Determination 2019/060

Regarding compliance with Building Code Clause B1 Structure of a multi-storey steel framed building at 230 High St, Christchurch

This determination considers the compliance of a recently-completed eight-storey steel framed building. Specific aspects of the completed frame had been brought to the notice of the authority, and the authority also questioned work carried out that varied from the approved consent. The determination considers the compliance of these matters in respect of Building Code Clause B1 Structure.

Figure 3: Frame elevations along Gridlines 5 and H – taken from building consent Drawings 100-S-024 and 100-S-025

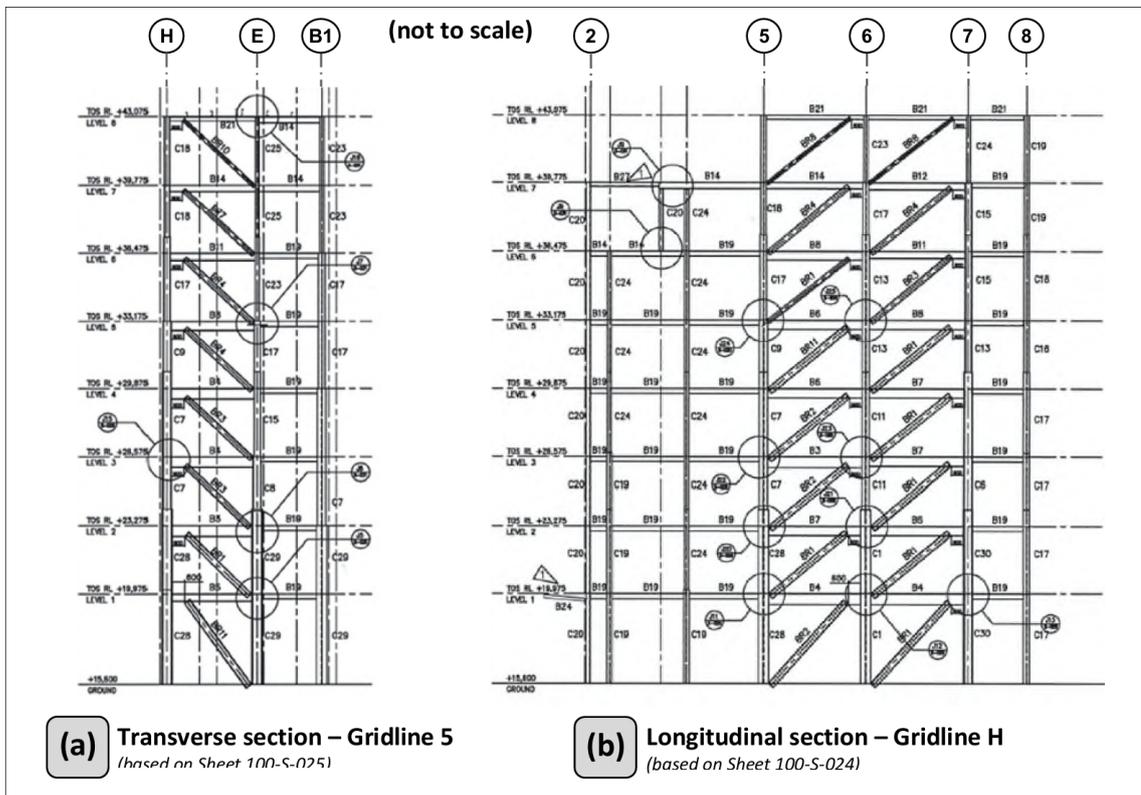
- The building is not capable of a ductile response given various design aspects including: detailing of the EBF active links into several columns; as the columns at Grids 5-H and 6-H are unable to support the overstrength actions of the active links from both directions; and as the EBF column splices generally are inadequate.

5. Column on Grid 5-H	<ul style="list-style-type: none"> Column on Grid 5-H roughly five times overloaded when considering overstrength shear forces of active links in both directions braces also noded eccentrically into the columns (does not show up in PSA model analysis) and these additional loads must be accounted for in the column design 	<ul style="list-style-type: none"> structure designed for limited ductility so does not need checking for concurrency of the seismic force because of ductile behaviour occurring at the link actions therefore considered to act separately along each of the two directions (NZS 1170.5 clause 5.3.1.1(a)); active links attached to columns in weak axis designed for inelastic deformation specified in NZS 3404 clause 12.11.3.3.3 calculations showed columns in Grid H have less load than in Grid 5; the perimeter EBFs in Grids B1 and H relatively stiff for the small floor area so there was less demand regarding the eccentrically noded braces, additional bending moment and shear to the columns was considered in the design 	<p>NOT in accordance with B1/VM1</p> <ul style="list-style-type: none"> this column's compressive capacity is approx. 12.5 MN, but the expert calculated the axial compressive demand as approx. 14.5 MN (i.e. more than the capacity) column's capacity reduced further when consider combined actions of axial load and bending moments the expert did not consider bending at this stage, but said moments were generated in both directions because of the transverse braced frame active link zone next to the column, and as the longitudinal braced frame's brace connection was eccentric to the column/beam centrelines

Figure 4: The modified brace on Grid 6 (circled) – taken from building consent Drawing 100-S-025 Rev 2

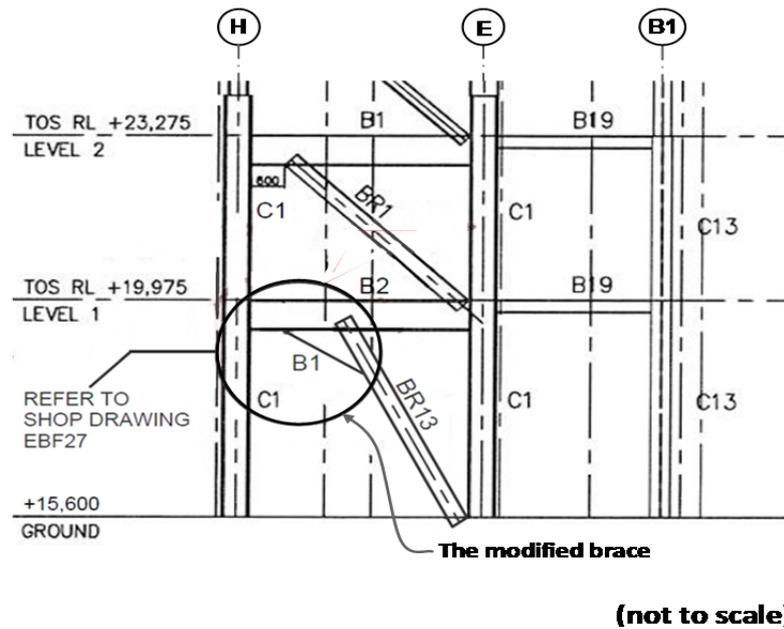
2.4.1 During construction, the bracing of the EBF at ground level on Grid 6 next to the stairwell was modified to enable access to the stairwell (refer to Figure 4). This modification involved moving the upper section of the brace member further along the beam and adding a gusset section taken from a hot rolled section of steel, which I assume was to maintain the geometry of the active link adjacent to the column at Grid 6-H.

2. Modified brace (ground level, Grid 6)	<ul style="list-style-type: none"> brace is highly eccentric and required to support 50% of the building's base shear demand – it would buckle well before the active link (a potentially dangerous failure mechanism) 	<ul style="list-style-type: none"> load transferred through the stiffened brace at the top, where a bending moment is applied as additional force and combined with the axial force brace designed to support this combined action; additional stiffener is provided at the base 	<p>NOT in accordance with B1/VM1</p> <ul style="list-style-type: none"> said beam and brace have sufficient capacity for the revised layout, but load path changed so moment in the active link zone is considerably higher this results in higher moments in the column and beam/column connection, which do not appear to have been checked in the frame redesign based on the expert's calculations the supporting column on Grid 6-H and the beam/column connection

2. Modified brace	Considered this detail was in accordance with B1/VM1; said analysis showed stress change (from original design) was mainly in the collector beam and brace; and the original section of the column was still satisfactory with the beam induced load.	Said the beam was 700 mm deep with a 450 mm clear yielding region, which did not conform with the HERA publication's requirements (i.e. that the yielding region must be as long as the beam depth). The revised beam size had insufficient capacity to support the original design loads and, as noted in the expert's final report, the amended bracing layout resulted in significantly higher actions in the beam, column and connection that had not been accounted for in the design.
